Site Accessibility Evaluation

Allmendinger Park
655 Pauline Blvd
Ann Arbor, MI 48104
ADA Only

Inspection Date: 07/11/2022

Report Date: 11/15/2022

2010 ADAS Section 505.4

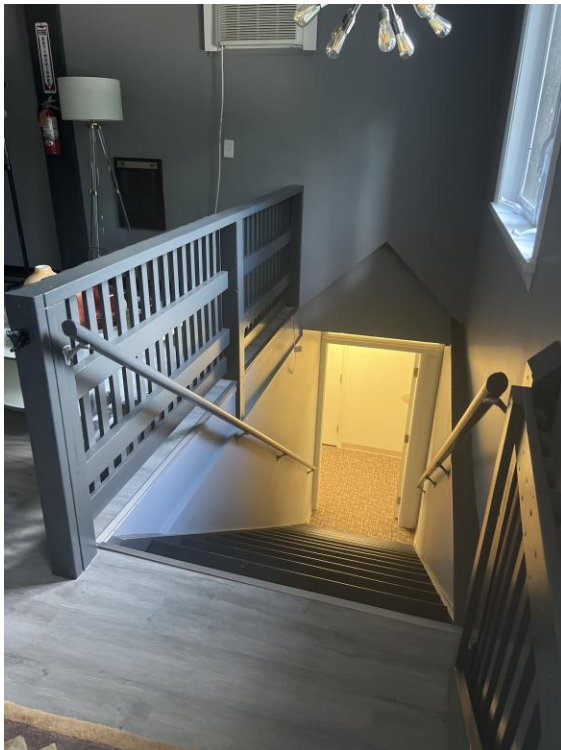
The handrails are not at the correct height.

Top of gripping surfaces of handrails shall be 34 inches (865 mm) minimum and 38 inches (965 mm) maximum vertically above walking surfaces, stair nosings, and ramp surfaces. Handrails shall be at a consistent height above walking surfaces, stair nosings, and ramp surfaces.

2010 ADAS Section 302.1

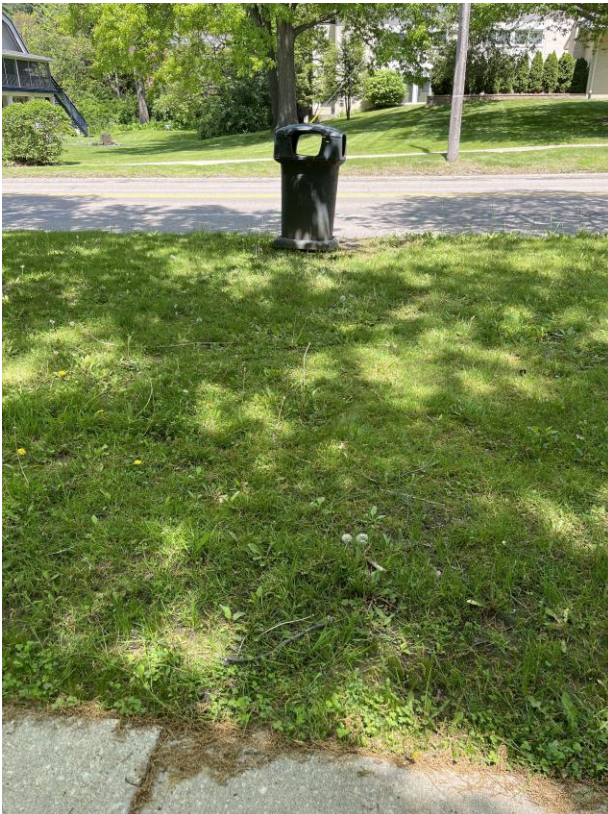
The accessible route contains loose gravel and/or surface materials that do not provide for a stable, firm slip resistant surface.

Floor and ground surfaces shall be stable, firm, and slip resistant and shall comply with 302.

2010 ADAS Section 302.1

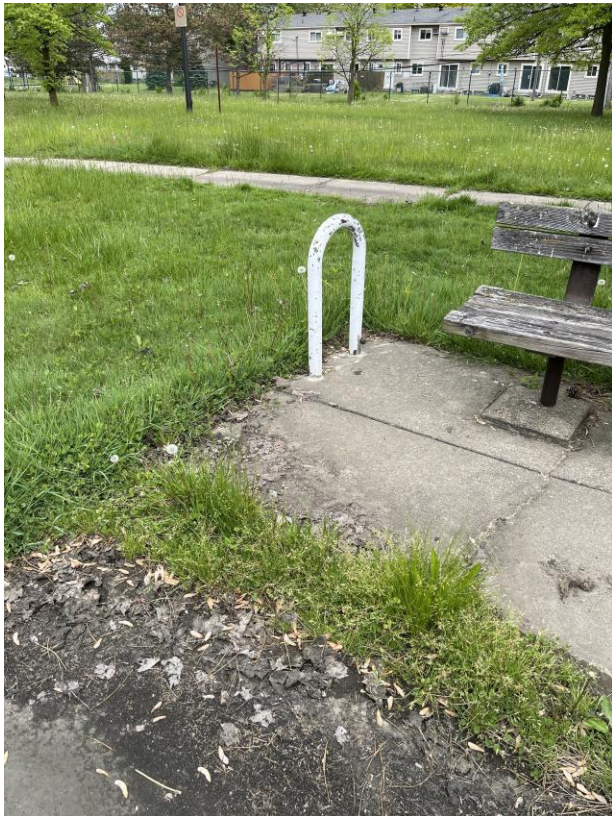
The accessible route contains loose gravel and/or surface materials that do not provide for a stable, firm slip resistant surface.

Floor and ground surfaces shall be stable, firm, and slip resistant and shall comply with 302.

2010 ADAS Section 302.1

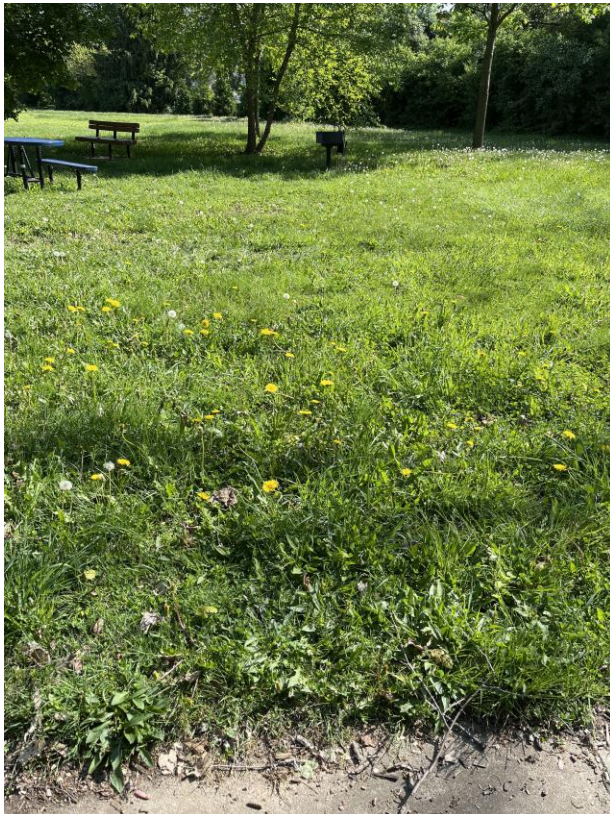
The accessible route contains loose gravel and/or surface materials that do not provide for a stable, firm slip resistant surface.

Floor and ground surfaces shall be stable, firm, and slip resistant and shall comply with 302.

2010 ADAS Section 502.2

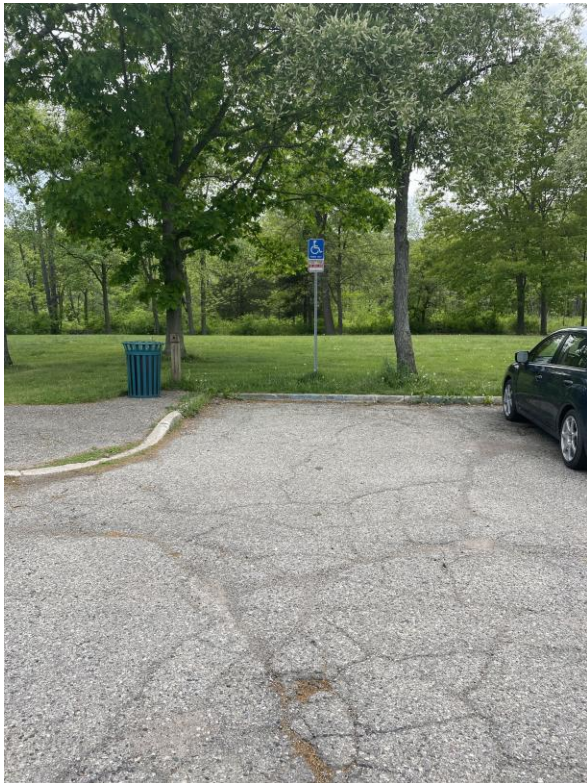
The parking space the minimum width. The floor or ground surface is not firm stable or slip resistant. The parking space contains changes in level and/or gaps that exceed the maximum allowable requirements. The parking space does not have the proper identifications signs or the signs are not installed at the correct height. The parking space is missing an adjacent access aisle.

Car parking spaces shall be 96 inches (2440 mm) wide minimum and van parking spaces shall be 132 inches (3350 mm) wide minimum, shall be marked to define the width, and shall have an adjacent access aisle complying with 502.3.
